# GXV3240/GXV3275 Firmware Release Note

## FIRMWARE VERSION 1.0.3.162

GXV3240, GXV3275

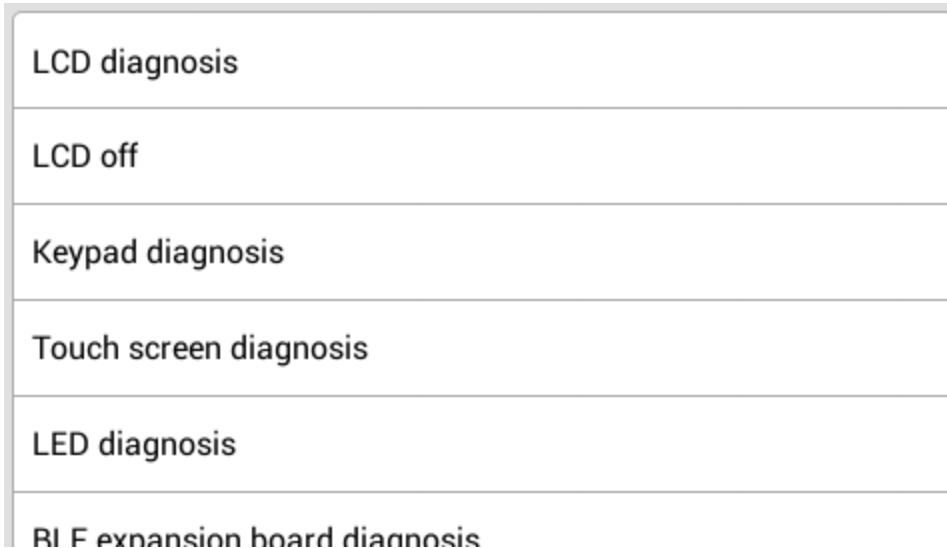
- Changed FileManager -> Internal storage icon.
- Supported new feature code "\*2016" to start factory function apk.  
From web UI -> Account -> Call Settings, set "Enable Call Features" to Yes. When dialing \*2016, DUT will start factory function app, see the picture below. Users can tap on each item to perform the corresponding diagnosis.

LCD diagnosis
LCD off
Keypad diagnosis
Touch screen diagnosis
LED diagnosis
R I F expansion board diagnosis
